ADDENDUM NO. 1

RED CLAY CONSOLIDATED SCHOOL DISTRICT
WILLIAM F. COOKE, JR ELEMENTARY SCHOOL
2025 Graves Road, Hockessin, DE 19707

THE WHITING-TURNER CONTRACTING COMPANY
CONSTRUCTION MANAGER
131 Continental Drive – Suite 404
Newark, DE 19713
302-292-0676 (phone)
302-292-0683 (fax)

CSK002

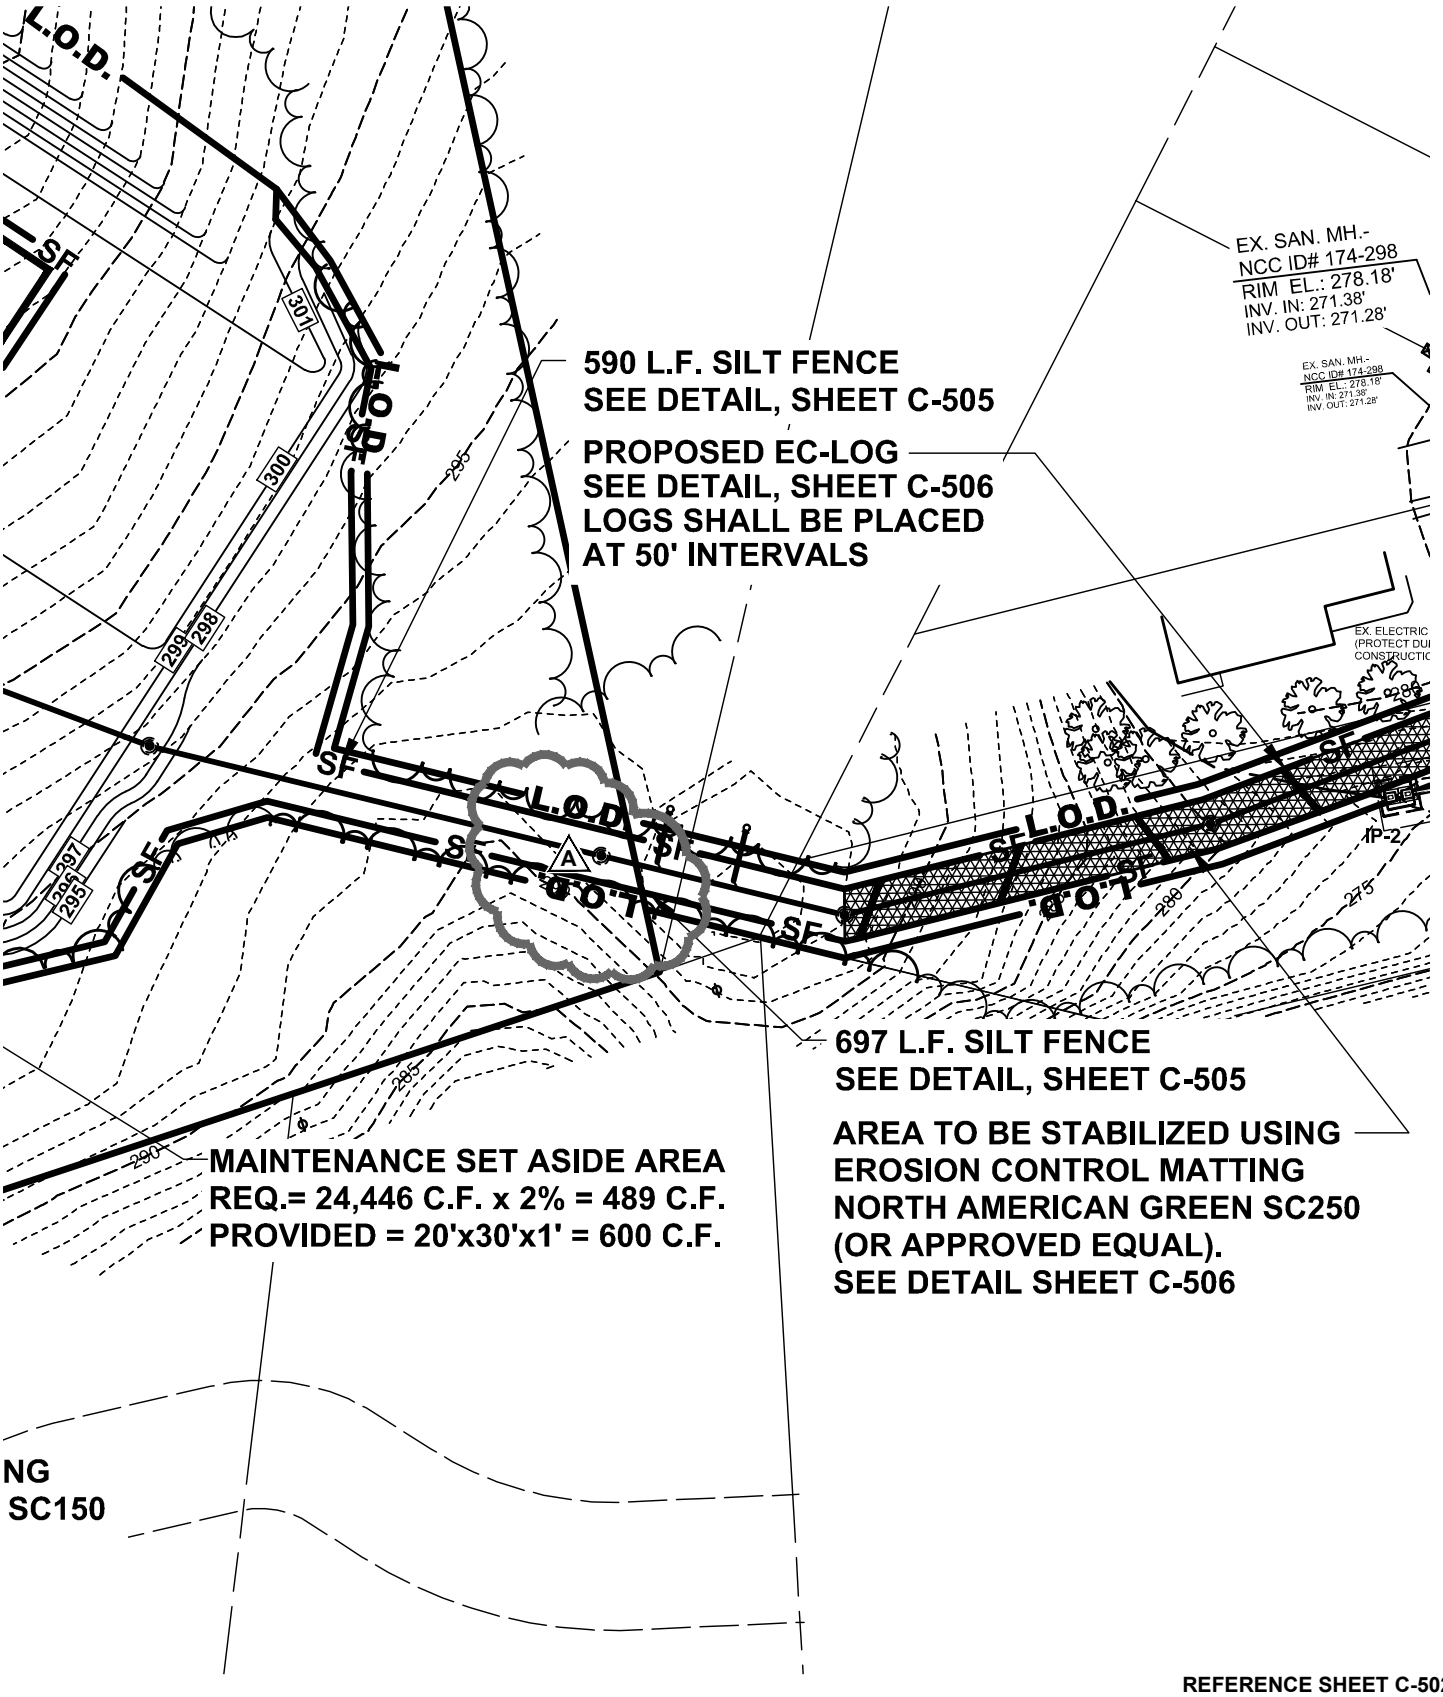
3.12.1 ADD new manhole (new San. M.H. 5) at southwest corner of property where sanitary sewer system enters from the adjacent property. – See sketch CSK-002.

CSK003

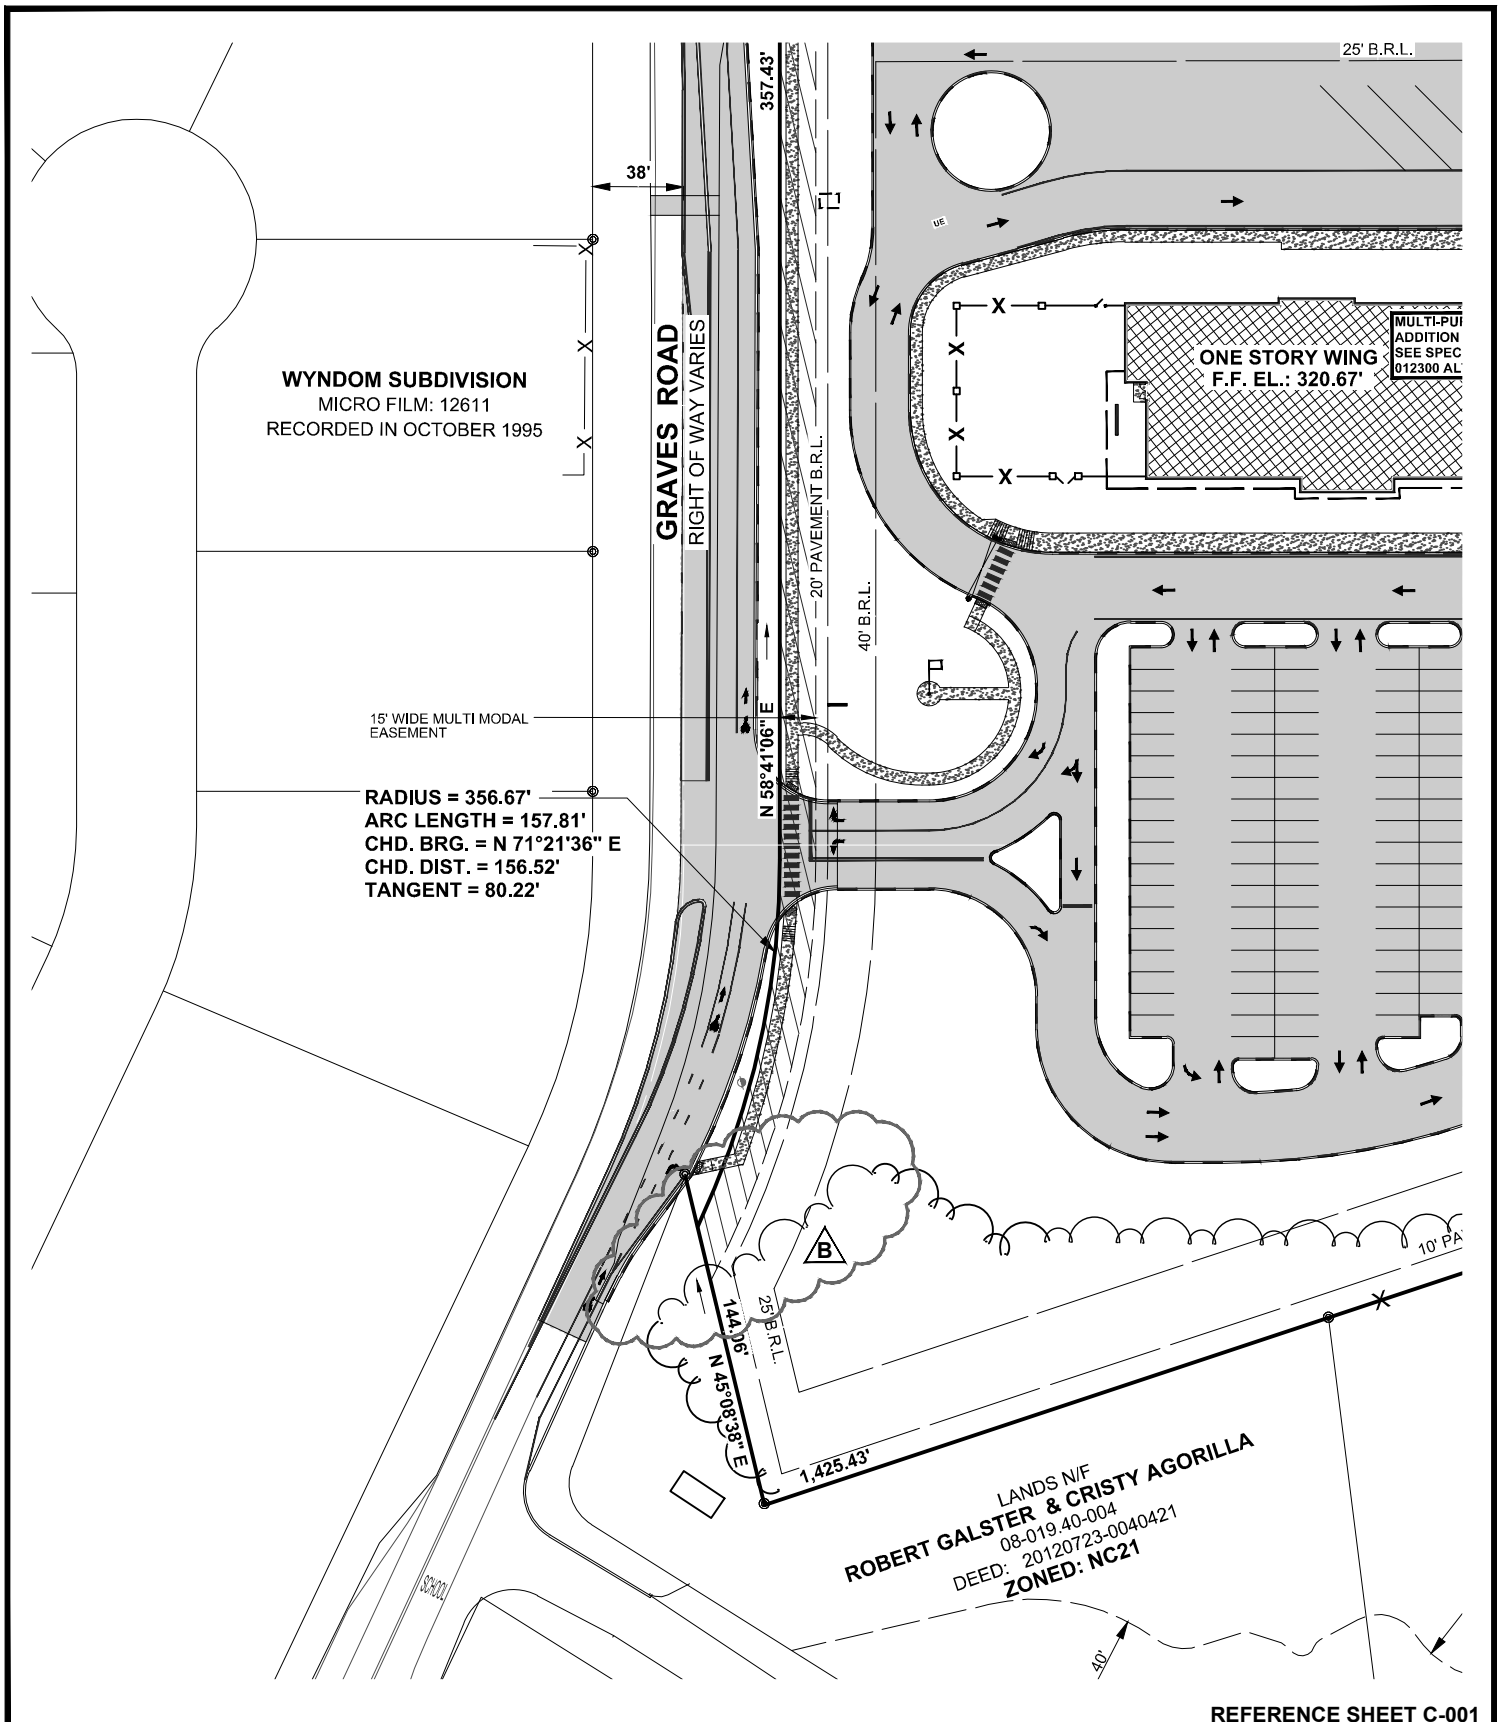
3.1.3 REVISE proposed new edge of wooded area at northwest corner of property along Graves Road (adjacent to Galster Property) per attached sketch CSK003.

CSK004

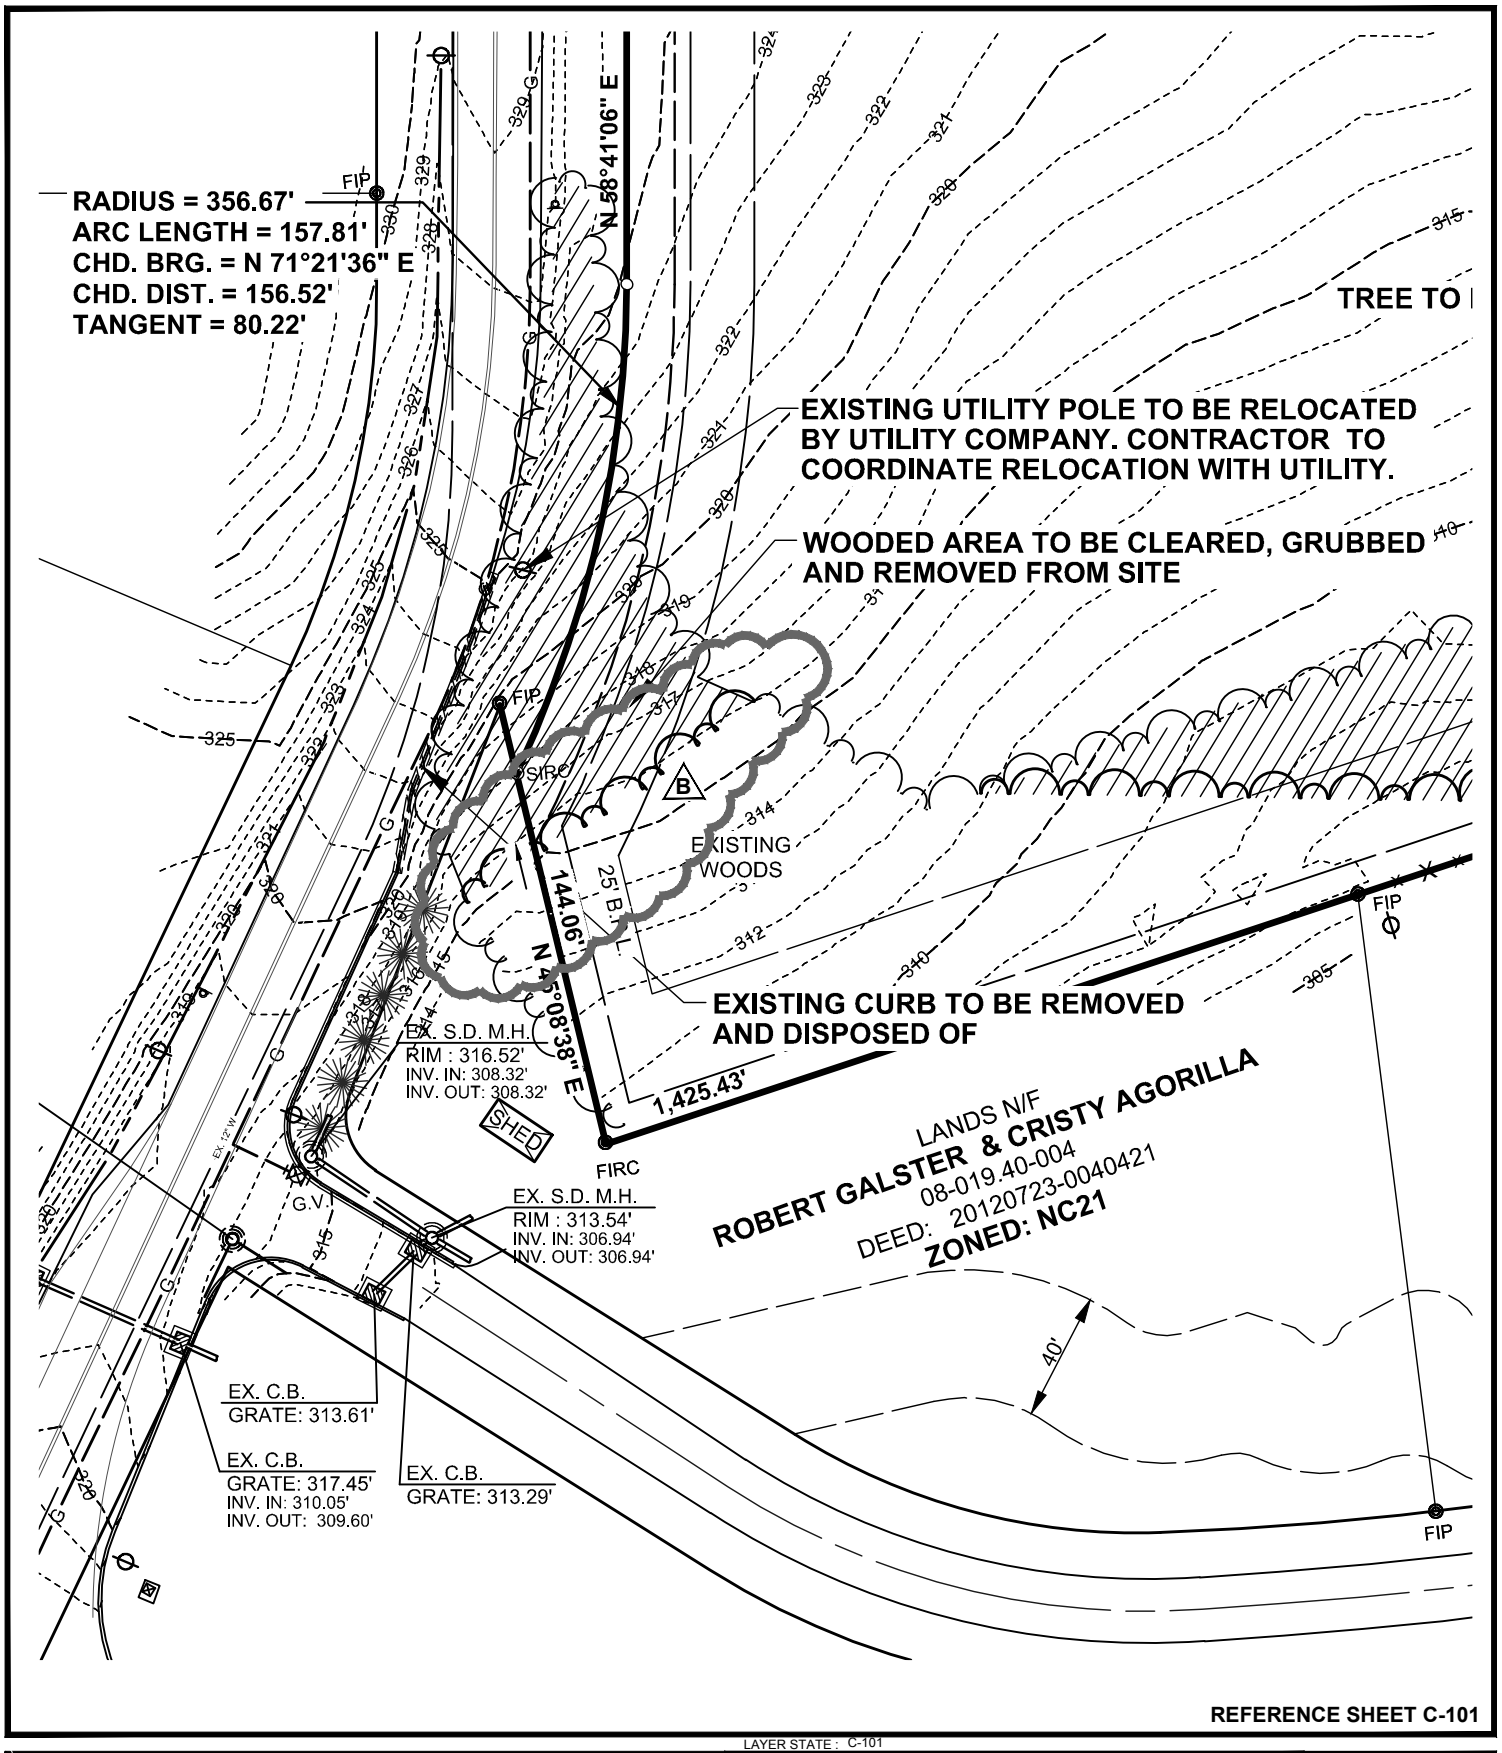
3.4 DRAWING C101 EXISTING CONDITIONS AND DEMOLITION PLAN
3.4.1 REVISE area of woods to be cleared, thus adjusting proposed new edge of wooded area at northwest corner of property along Graves Road (adjacent to Galster Property) per attached sketch CSK004.

CSK006

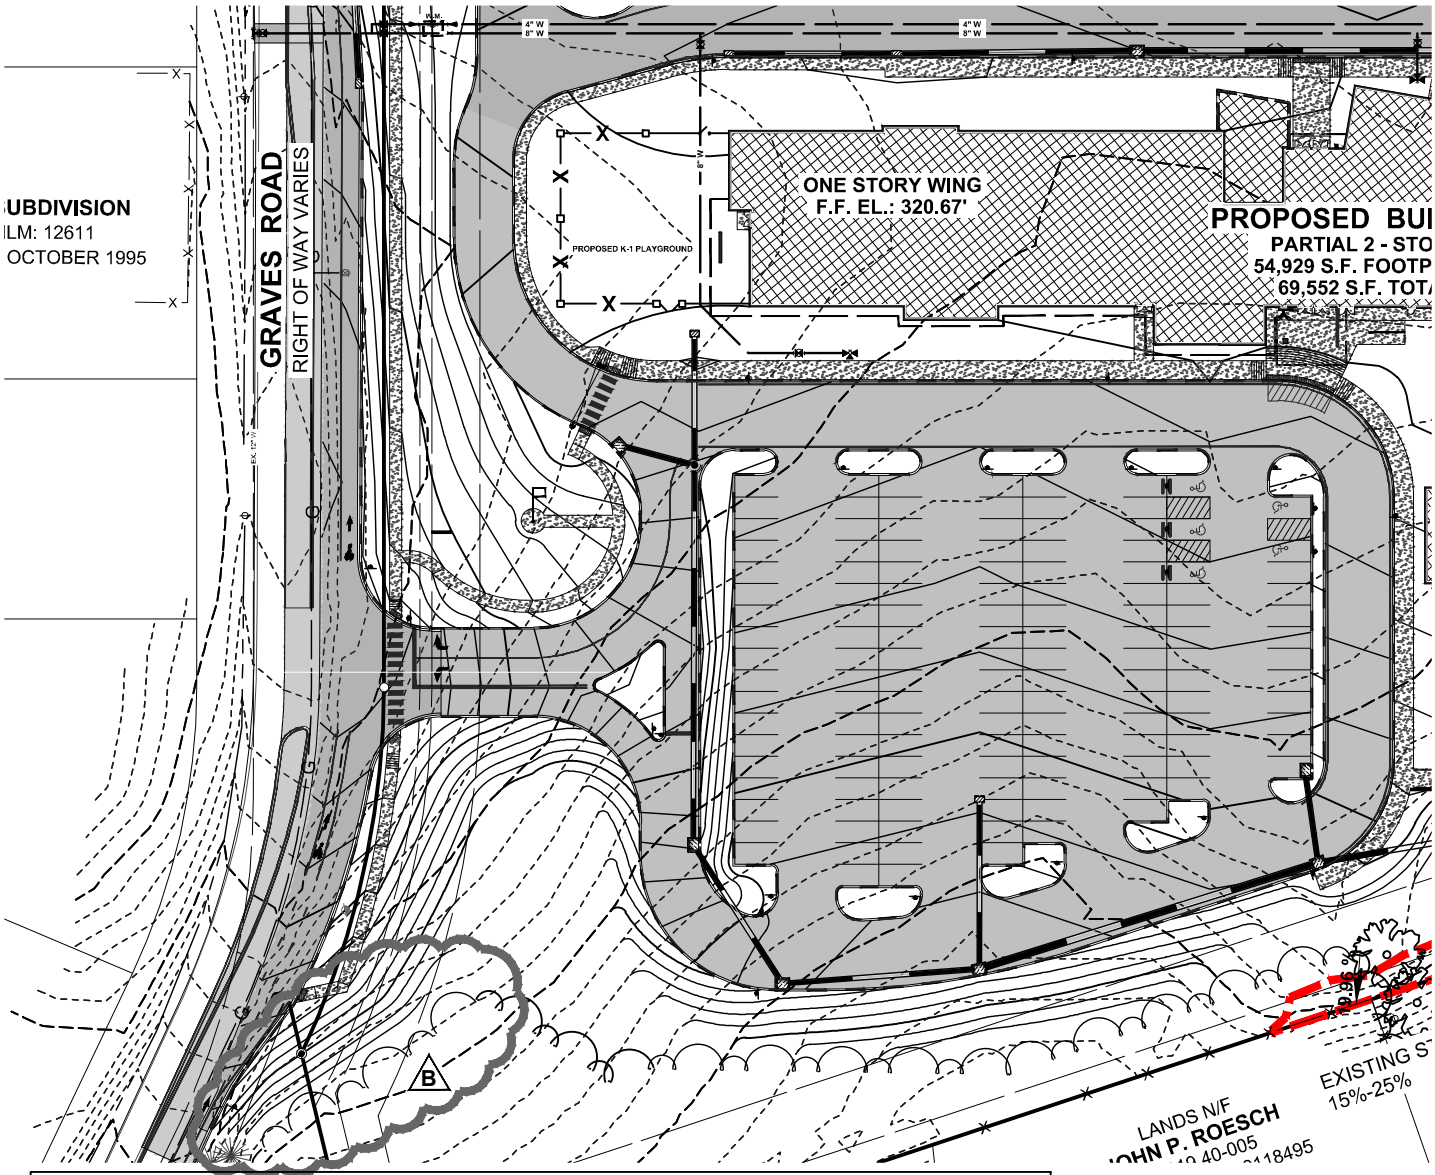
3.5.5 REVISE proposed new edge of wooded area at northwest corner of property along Graves Road (adjacent to Galster Property) per attached sketch CSK006.

3.5.6 REVISE grading at northwest corner of property along Graves Road (adjacent to Galster Property) per attached sketch CSK006.
3.5.7 REVISE sanitary sewer lateral table, lateral 1 and 2 at invert at connection point per attached sketch CSK006.
